Work Order ID 71045

Item Name: Crosstube Aft, Blue

DRAWING NO. D206-667-243	TITLE CROSSTUBE ASS'Y (206L HIGH AFT)	REV. C	DART AEROSPACE LTD ENGINEERING ORDER		D.E.O. NO. D206-667-243-C-1	SHEET NO. SHEET 1 OF 1	SCALE NTS
DRAWN 92	CHECKED ASS	MFG. APPR. RB	APPROVED MP		DE APPR. #		
DATE 11.07.15	DATE 11.07.20	DATE 11.07.21	DATE 11/07/21		DATE 11.07.21

REPLACE MAGNOBOND WITH PROSEAL.

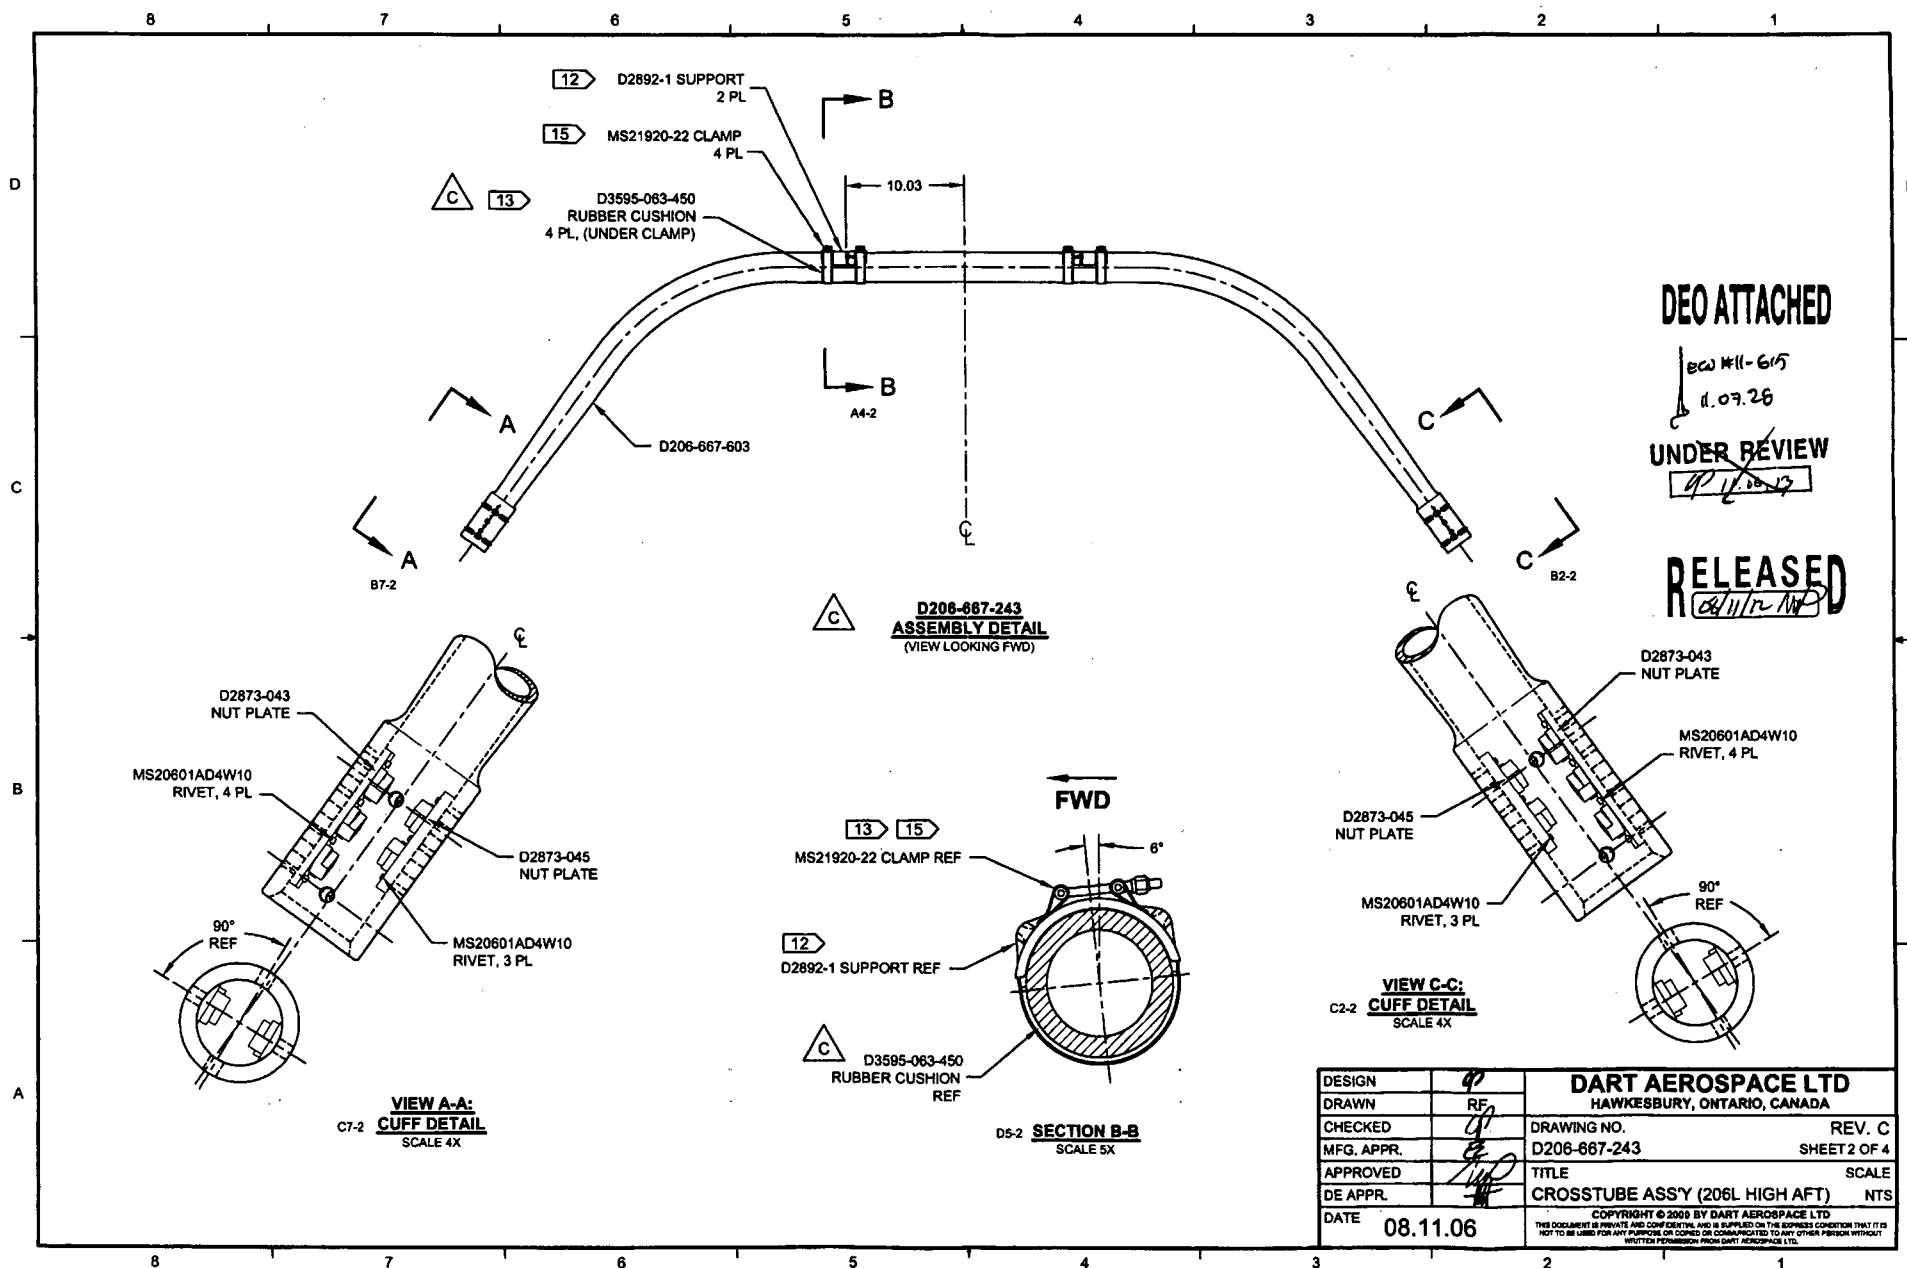
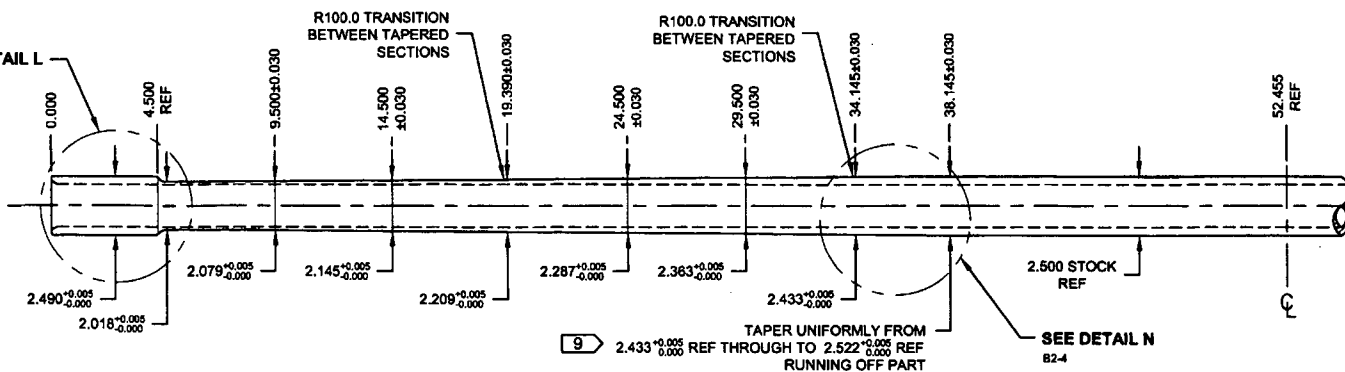
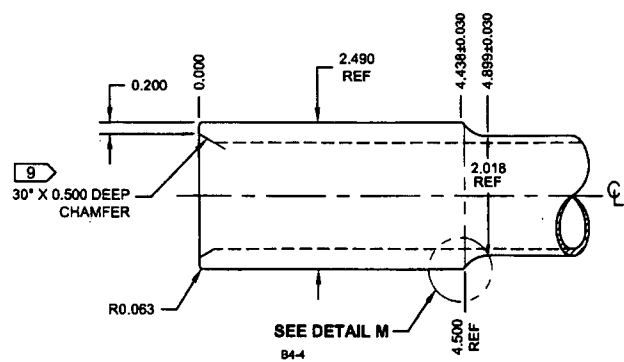
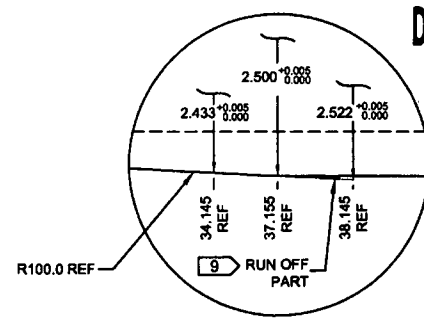
NOTE 12 & 15, SHEET 1 IS AMENDED AS FOLLOWS:

Item	Qty -243	Part Number	Description
9	A/R	PROSEAL 890 B-2	SEALANT, AMS-S-8802 CLASS B-2

- 12) TO INSTALL D2892-1 SUPPORT: ABRABE MATING SURFACE OF SUPPORT AND CROSSTUBE WITH 180-GRIT SANDPAPER AND REMOVE RESIDUE WITH MEK (OR EQUIVALENT). APPLY A 0.04" TO 0.07" THICK LAYER OF PROSEAL 890 CLASS B-2 (OR AMS-S-8802 CLASS B-2) SEALANT TO MATING SURFACE OF SUPPORT.
- 15) TORQUE CLAMPS 80 TO 100 IN-LB. ENSURE AT LEAST 1.5 THREADS SHOWING IN SAFETY AND THAT NUT HAS NOT BOTTOMED-OUT AFTER TORQUING. **PRIOR TO PACKAGING, RE-CHECK TORQUE ON CLAMPS AFTER PROSEAL 890 SEALANT HAS CURED FOR 72 HOURS.**
